**ALBERTA TRANSPORTATION SPRINGBANK OFF-STREAM RESERVOIR PROJECT
RESPONSE TO NRCB AND AEP SUPPLEMENTAL INFORMATION REQUEST 1, JULY 28, 2018**

Errata
May 2019

10 ERRATA

Figure IR589-1 Seasonal Variation Metrics of Total Suspended Sediment in the Elbow River Mainstem and in the Glenmore Reservoir from 1979 to 2016

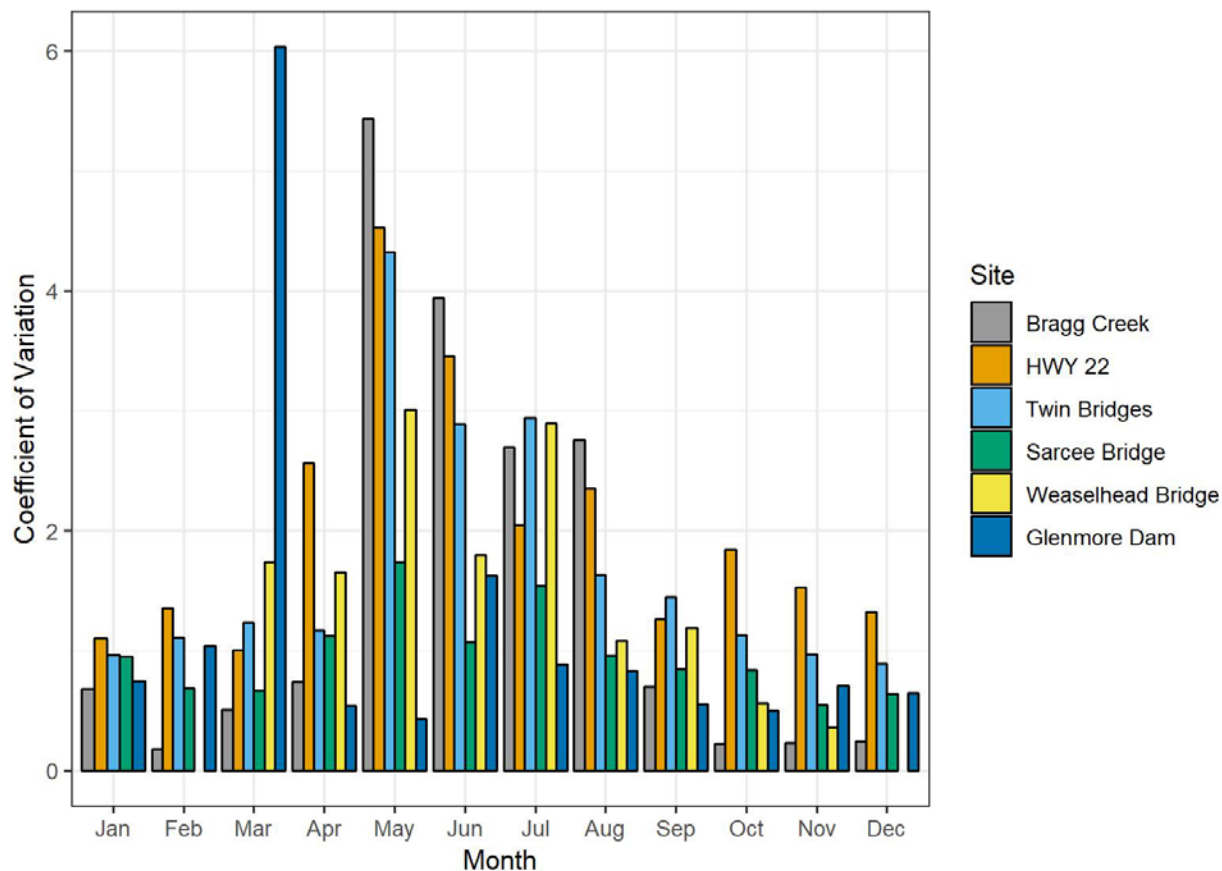
The graph is supposed to show the seasonal variation for the Elbow River mainstem and at the Glenmore Reservoir. The Glenmore Reservoir bars are missing.

- a. Add the Glenmore Reservoir bars and provide the updated graph.

- a. Figure IR589-1 provides the requested additional information.

Figure IR593-1 Monthly Total Suspended Sediment Seasonal Variability Metric (using data from 1979 to 2016)

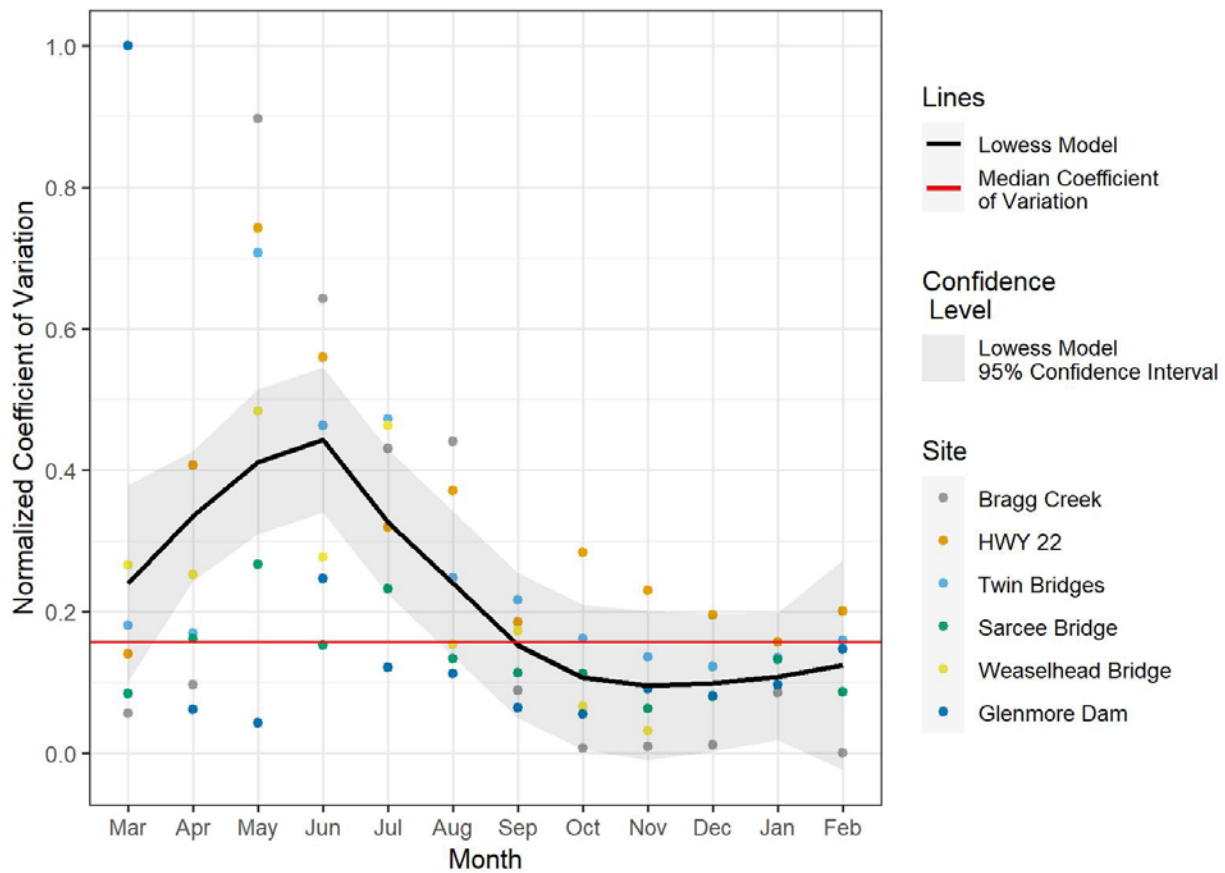
The figure has a legend for different lines and areas in the graph.

- b. Explain why all five dots for the month of May are outside the Lowess 95% confidence interval area.
- c. The figure heading indicates that it applies for the summer season; however, the 'x' axis includes months for a full year. Clarify this discrepancy.

- a. Figure IR593-1 provides the requested information.

- b. The Lowess Model curve and the 95% confidence boundaries reflect the central tendency and spread of the monthly coefficient of variations over time. The line representing the Lowess model curve (termed the locally weighted scatterplot smoothing model) and the accompanying 95% confidence intervals are smoothed to better show relationships in the data. Thus, the outside boundary of the 95% confidence interval for any one month reflects the confidence interval of the previous and post months as well. As a result, not all points fall within the 95% confidence interval.

- c. The reference to "summer" in the title for Figure 3-2 (Volume 4, Appendix K, Section 3) is regarding the area within the 95% confidence interval during summer (i.e., the area shaded yellow). This was done to provide an example on how the seasonal variation metrics for each parameter were compared to the seasonal variation metric for total suspended sediments according to season. (note: the yellow area is removed in Figure IR593-1 provided in response a to avoid confusion).
